COMMENT LETTER # 2

July 6, 2006

Re: Shingle Springs Interchange Project
03-ED-50-KP R 16.6/R 18.7
State Clearinghouse Number: 2001072018

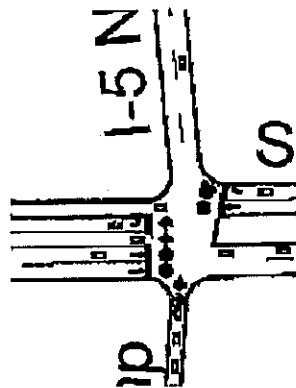
- 1) The following geometrics were used in the analysis of the Sunset Hills/SB Ramps intersection:

SB – 2 lefts and 1 free right (storage length of 150')

EB – 2 thru and 1 free right

WB – 2 lefts (storage length of 100') and 1 thru lane
